November 1, 1985
JPN-85-80

Subject: James A. FitzPatrick Nuclear Power Plant
Docket No. 50-333
Response to Request for Additional Information
Regarding SPDS/EPIC

Response to USNRC June 17, 1985 Request for Additional
Information Regarding Safety Parameter Display System

FIGURE 1
OVERVIEW OF SYSTEM

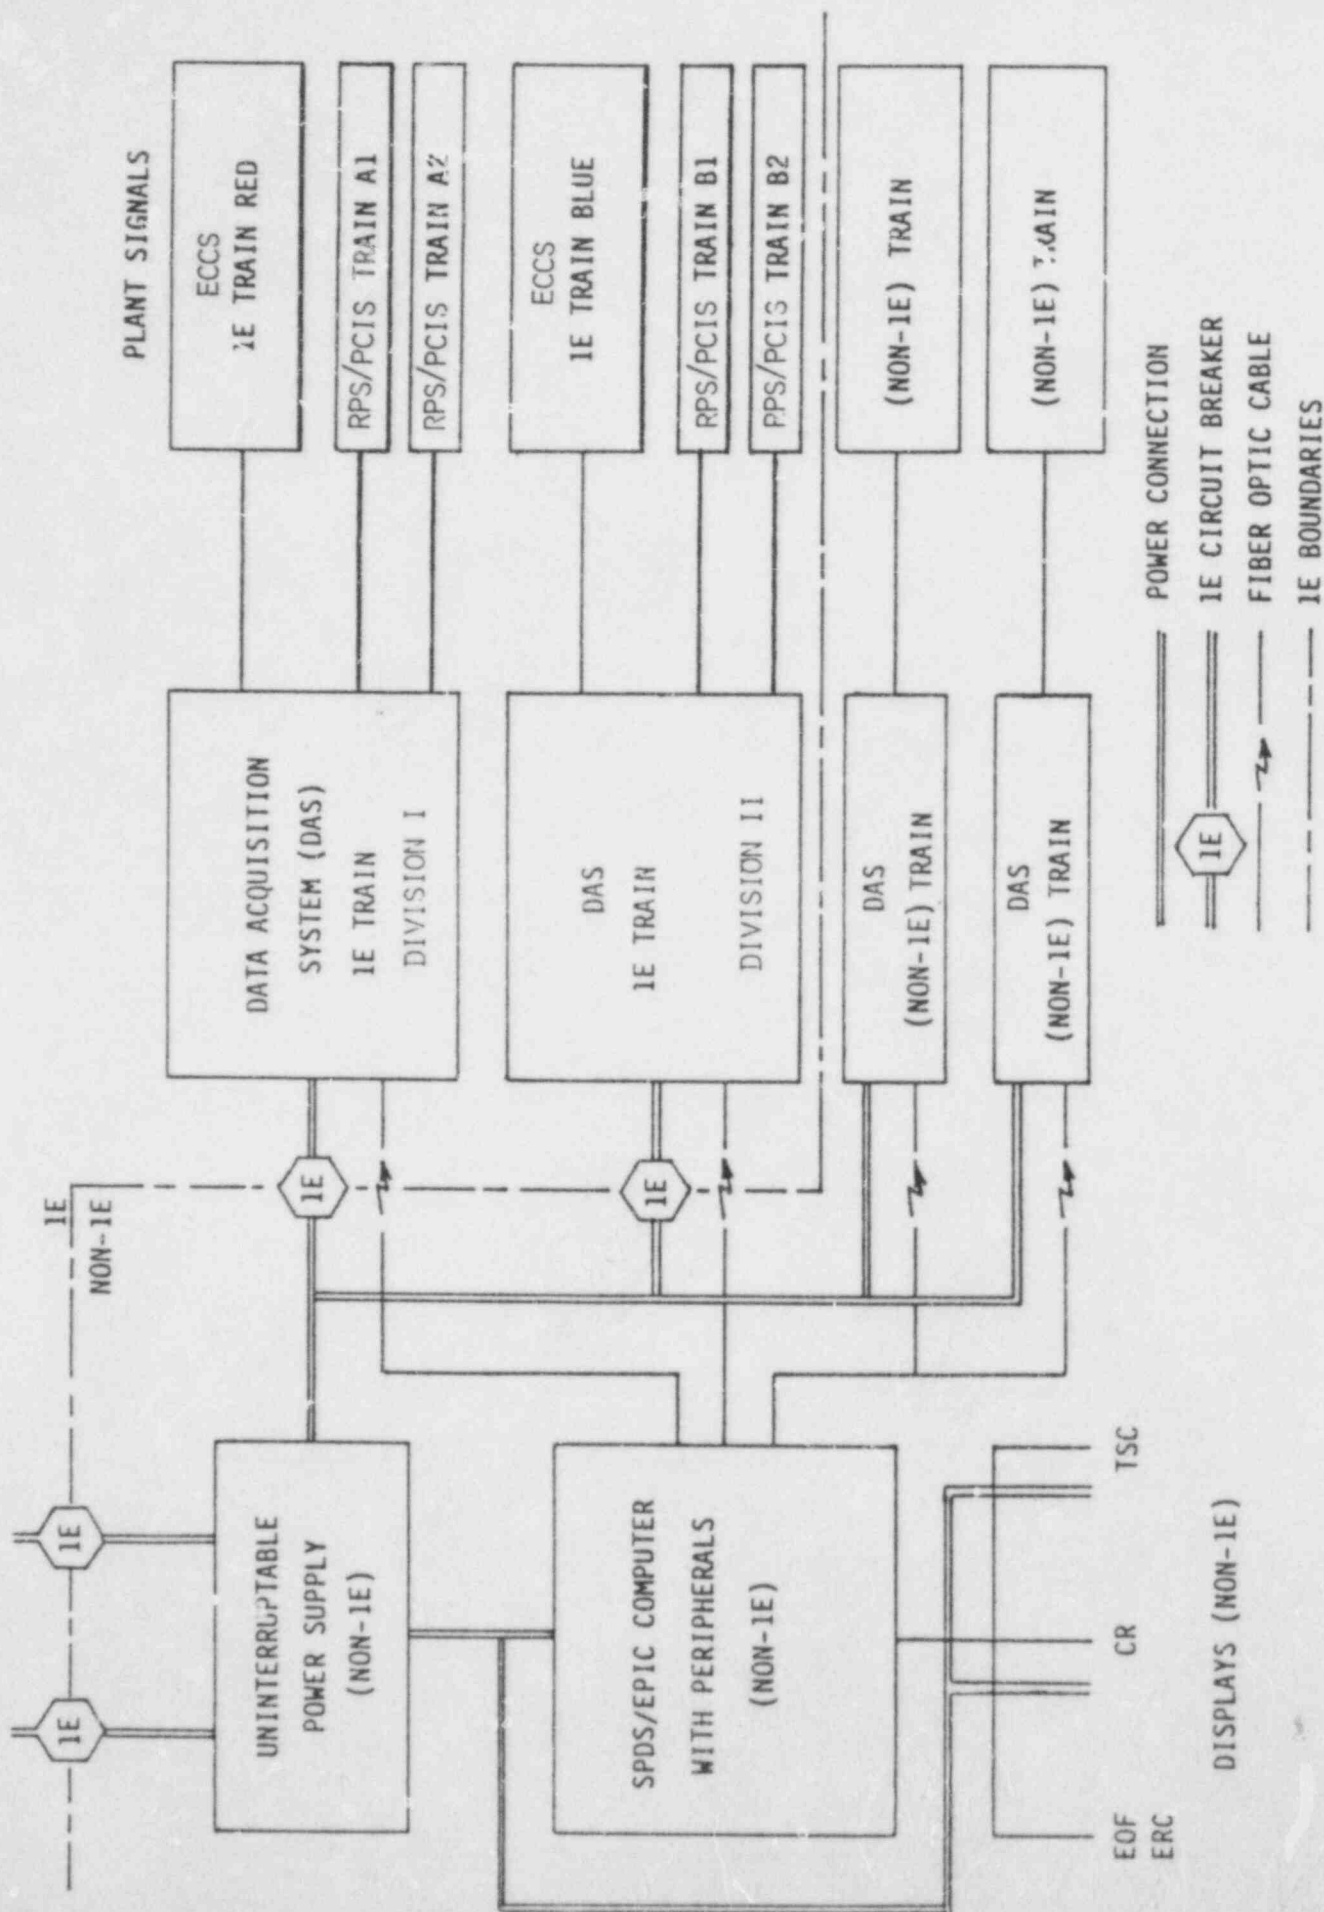
For each type of device used to accomplish electrical isolation, describe the specific testing performed to demonstrate that the device is acceptable for its application(s). This description should include elementary diagrams where necessary to indicate the test configuration and how the maximum credible faults were applied to the devices.

The EPIC/SPDS system, (Figure 1), consists of both 1E and non-1E equipment which interfaces with two Emergency Electrical Divisions (I and II) and the four Reactor Protection System Channels (A1, A2, B1 and B2) in the FitzPatrick plant.

Also shown in Figure 1 is the 1E DAS, which interfaces with the two Emergency Divisions and the four RCS/PCIS Divisions. The 1E DAS equipment has been designed and tested to meet the seismic requirements of IEEE-344, "IEEE Recommended Practices from Seismic Qualification of Class 1E Equipment for Nuclear Power Generating Stations" and the environmental requirements of IEEE-323-1974, "IEEE Standard for Qualifying Class 1E Equipment for Nuclear Power Generating Stations" and can therefore, be safely connected to the 1E plant equipment. The DAS 1E equipment is isolated from the non-1E computer and power equipment in accordance with IEEE-384, "IEEE Standard Criteria for Independence of Class 1E Equipment and Circuits".

FIGURE 2

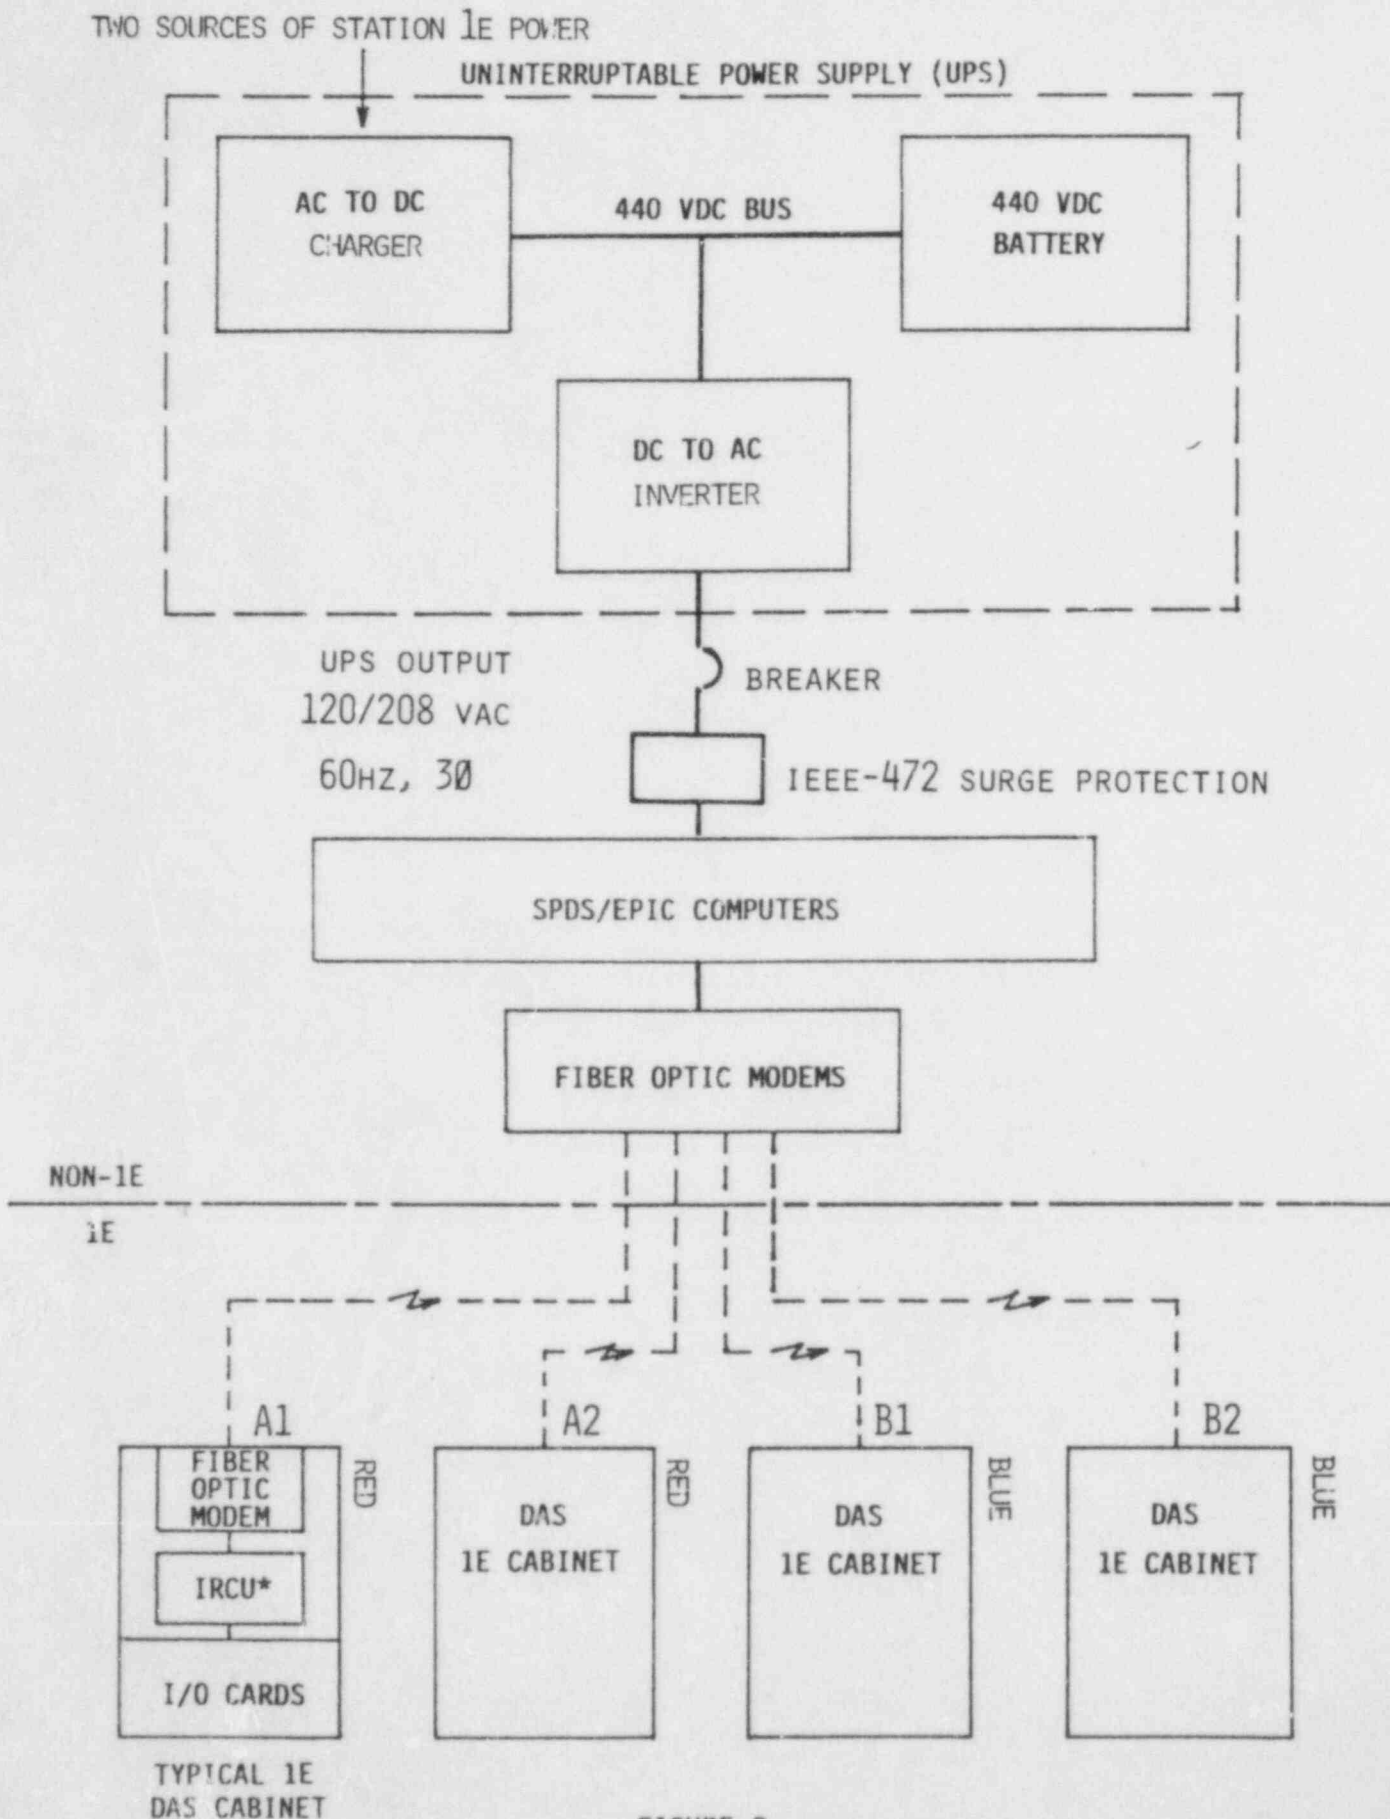
The isolation between the central computers and the 1E DAS equipment is shown on Figure 2. It consists of high speed digital fiber optic links to each 1E cabinet. Each cabinet is independent of the others, connected only by the fiber optic link and the AC power supply.

- R1a. I. The EPIC/SPDS System uses fiber optic cable and modems for information transfer between the DAS equipment and the SPDS/EPIC computers (Figure 2). The fiber optic cable is constructed totally of non-conductive material with fiber optic cable between modems. Given the characteristics of fiber optics in a mild environment, there is no possibility of any voltage, current, or electromagnetic interference being passed through the cable between the optical modems.

R1b. I. The maximum credible voltage that could be applied to the fiber optic interface is 600 VAC, the input of the dedicated EPIC/SPDS UPS, or 452 VDC, the highest DC voltage generated on the UPS DC bus. The UPS converts input power to 440 VDC, and then recreates 120/208 volt 3-phase AC power for the SPDS/EPIC computers and DAS. The only connection between the input AC to DC charger and output DC to AC inverter is the DC bus and batteries. The input power is 600 VAC. It would take multiple failures to exceed this voltage. Additionally, surge protection devices qualified to IEEE 472, "IEEE Guide for Surge Withstand Capability (SWC) Tests", have been installed in the power distribution system between the UPS and computer (Figure 2).
